First Amendment to the Draft Subsequent Environmental Impact Report

America Center Phase III Project

File Numbers: PDC15-058 and PD15-053
State Clearinghouse Number: 2016092066

November 2017

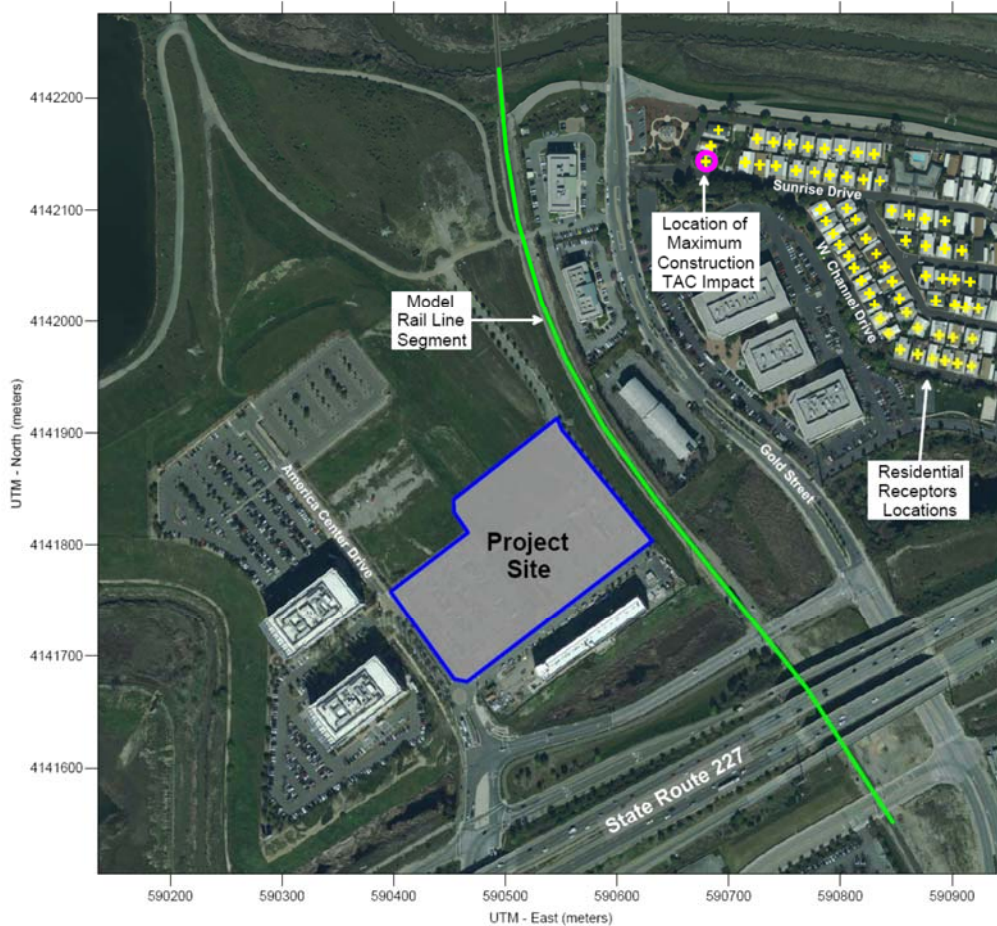
Comment D-2: Construction of the Project will require numerous pieces of heavy diesel equipment, which are a substantial source of toxic air contaminants (TACs). The DSEIR dismisses TAC impacts from construction as less than significant without any actual analysis because it concludes that the nearest sensitive receptors are 950 feet away from the Project site. However, the BAAQMD CEQA Guidelines, which the DSEIR relies upon, recommend that the lead agency assess TAC risks to all receptors within 1,000 feet of a project. BAAQMD, CEQA Guidelines, 2017, p. 5-7. Furthermore, there appear to be sensitive receptors directly adjacent to the Project in the now separate development area identified as the River Commercial Area, including two hotels and the Alviso Youth Foundation Project. The DSEIR should provide a quantitative health risk assessment of construction TAC impacts following standard modeling protocols.

The DSEIR fails to evaluate cumulative health impacts from TAC emissions as required by CEQA. Instead, the DSEIR simply assumes that they will not be significant if other cumulative projects implement mitigation similar to what it calls "MM AQ-1.1." DSEIR, p. 176. There is no "MM-AQ-1.1" identified in the DSEIR. There is a Mitigation Measure AIR-1.1, but that measure is intended to address NOx impacts, not TAC impacts. Furthermore, the point of cumulative analysis is to identify situations in which individually minor impact may still result in significant cumulative impacts. Thus, mitigation by individual projects does not ensure that there would be no cumulatively significant impact.

Here, the DSEIR acknowledges that air quality at the southern end of the Bay is already degraded compared to the rest of the Bay Area due to natural barriers and prevailing winds. It also acknowledges that one goal of the BAAQMD Clean Air Plan is to address regional disparities in air quality impacts. The Alviso community in particular suffers comparatively worse air quality than other locations in the Bay Area. Finally, the DSEIR admits that a number of construction projects adjacent to the Project site are scheduled to occur in the same time frame. DSEIR, p. 174.

Response D-2: A construction period TAC impact analysis was prepared by Illingworth & Rodkin for the project to document quantitatively the conclusions in the DSEIR. The analysis is provided in this document as Appendix F: Construction TAC Analysis, dated August 18, 2017 in Section 4.0 of this document. In addition, the two adjacent hotels are not considered sensitive receptors per the definitions in the BAAQMD CEQA *Air Quality Guidelines*.

receptors to the project site are residences along West Channel Drive at the Summerset Mobile Estates, located approximately 900 from the project site (as shown in the figure below). Emissions and dispersion modeling was conducted to predict the off-site toxic air contaminant (TAC) and PM_{2.5} concentrations resulting from project construction, so that lifetime cancer risks and non-cancer health effects could be evaluated. The analysis included a conservative estimate of impact as default construction assumptions from CalEEMod were used, as well as a conservative construction timeline.
